Textown Limited

Dewan Idris Road, Ashulia, Savar, Dhaka, Bangladesh.

11.MARCH.2014

Identified Priority 1 Concerns

Escape Staircase is in Poor Condition

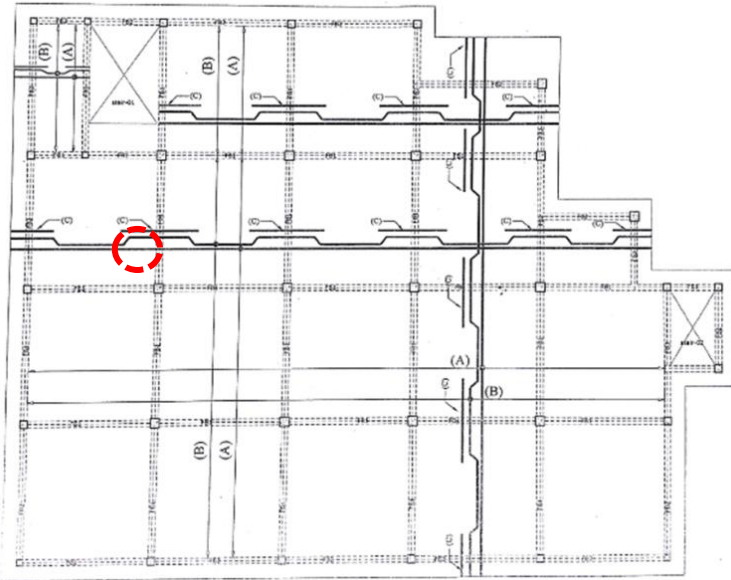
The staircase at the side of Building 03 is meant to be a fire escape staircase. This means that there is a potential for crowds of people to use this stair in the event of emergency. However, the stair was built from very small steel members, and had not been properly galvanised, and therefore had rusted very badly. The structural stability of this staircase is questionable, and appears unsafe for its intended purpose

- Consider the renewal of this staircase, using suitable corrosion-resistant materials, and of a design suitable for emergency and panic loading.
